FINAL STRUCTURAL REQUEST
ACKNOWLEDGMENT

ROYAL
COLLECTION
AT KEELE & KING

DOVER
ELEVATION A - 2860 SQ. FT.
ELEVATION B - 2817 SQ. FT.

Lot 73
Elev. B.

BASEMENT
ELEVATION A

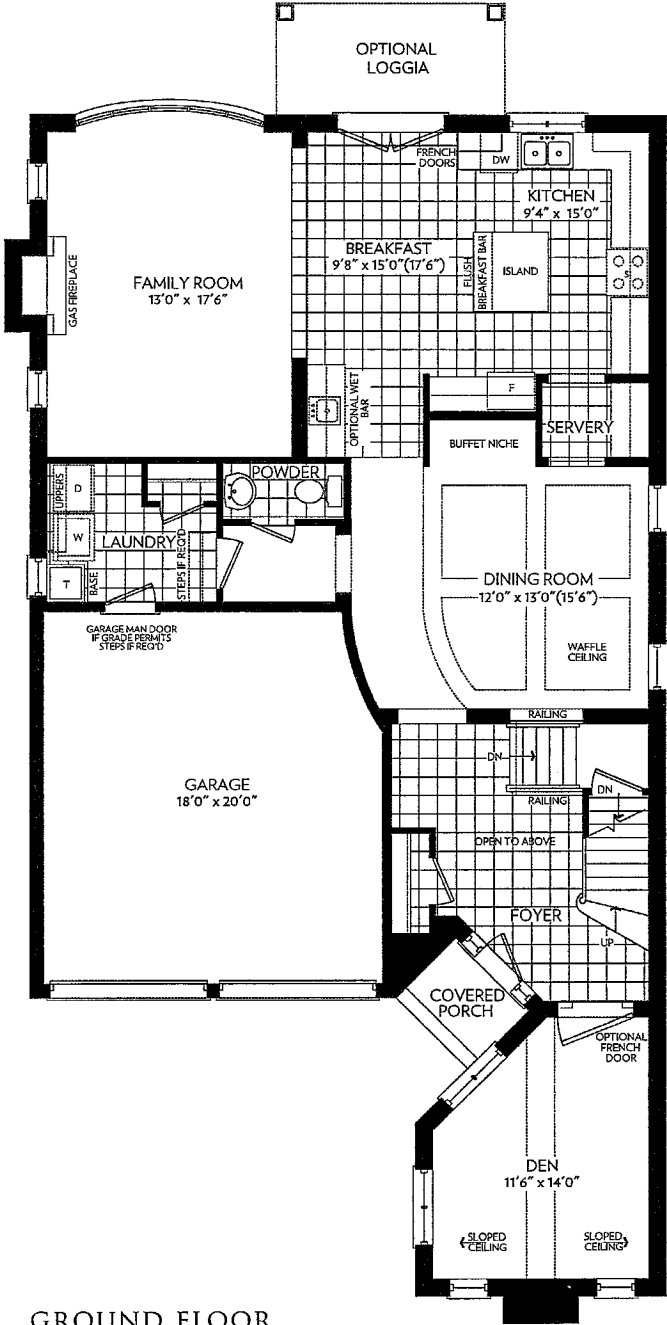
ID	Group	Description	Invoice	Date Ordered	
9923	STRUCTURAL	BASEMENT WINDOWS Enlarge 5 basement windows to 24 inches high x 30 inches wide	1939		
9924	STRUCTURAL	PLUMBING - KITCHEN Water line to fridge	1939		
9925	STRUCTURAL	EXTERIOR BRICK Upgraded brick Package 10 **pending approval	1939
